January 2020  
FL841A  
NHTSA #19V-869  
Transport Canada #2019-611

## Subject: FCCC School Bus Chassis Fan Clutch Bolts

**Models Affected: Specific Model Year 2020-2021 FCCC B2 school bus chassis (Thomas Built Buses Saf-T-Liner C2) manufactured January 21, 2019, through October 11, 2019, and equipped with a DD5 engine.**

**Fig. 1, Fan Clutch Assembly**

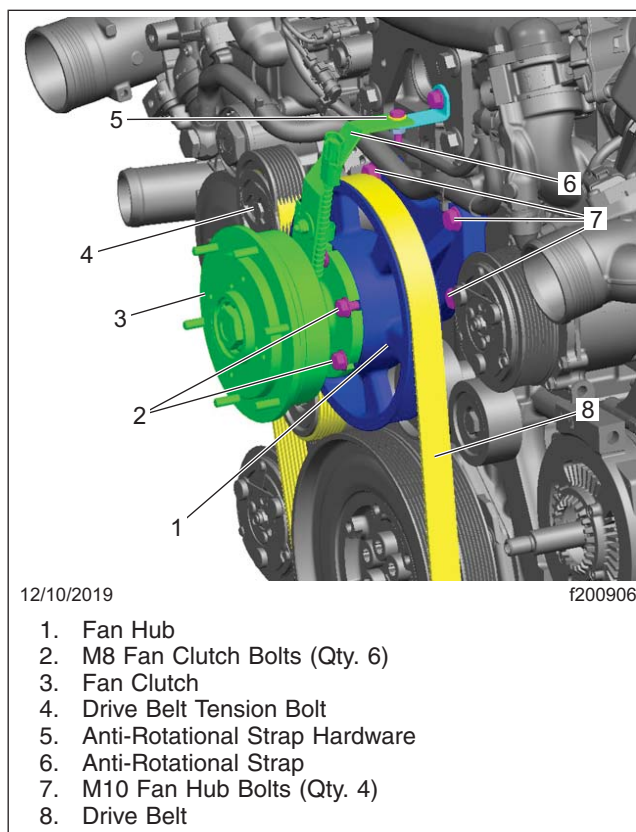
1. Check the base label (Form WAR259) for a completion sticker for FL841 (Form WAR260) indicating this work has been done. The base label is usually located above the driver's window. If a sticker is present no work is needed. If there is no sticker, proceed with the next step.
2. Park the vehicle on a level surface, shut down the engine, and set the parking brake. Chock the tires.
3. Remove the six nuts that attach the fan blade assembly to the fan clutch and set the fan aside. Discard the nuts.
4. Disconnect the fan clutch connector.
5. Remove the bolt and nut from the anti-rotational strap and set aside. See [Fig. 1](#).
6. Loosen, but do not remove, the six fan clutch bolts. See [Fig. 1](#).

7. Using a long-handle ratchet and 15 mm socket, carefully push down on the drive belt tensioner and slide the belt off of the idler pulley.
8. Remove the six fan clutch bolts and set the fan clutch to the side.

9. In a criss-cross pattern, remove and replace the four fan hub bolts, one at a time. Tighten the new bolts  $35\pm4$  lbf·ft ( $47\pm5$  N·m).

10. Using new bolts, install the fan clutch.
  - 10.1 Ensure that the fan clutch is properly seated on the hub and that the new bolts are started and snug before tightening.

- 10.2 Using a long-handle ratchet and 15 mm socket, carefully push down on the drive belt tensioner and slide the belt over the idler pulley. Ensure that the drive belt is aligned on all pulleys; repeat as needed to properly align the drive belt.
  - 10.3 Tighten the bolts  $17\pm2$  lbf·ft ( $23\pm3$  N·m).
11. Using the hardware removed earlier, install the anti-rotational strap. Tighten the bolt 60 lbf·in (678 N·cm).
12. Connect the fan clutch connector.
13. Using new hardware, install the fan blade assembly. Tighten the nuts 19 lbf·ft (26 N·cm) in a diagonal pattern.
14. Start the engine and listen for any unusual noise. Look at the drive belt and ensure it is properly aligned.
15. Clean a spot on the base label (Form WAR259). Write the recall number, FL841, on a blank completion sticker (Form WAR260), and attach it to the base label to indicate this recall has been completed.
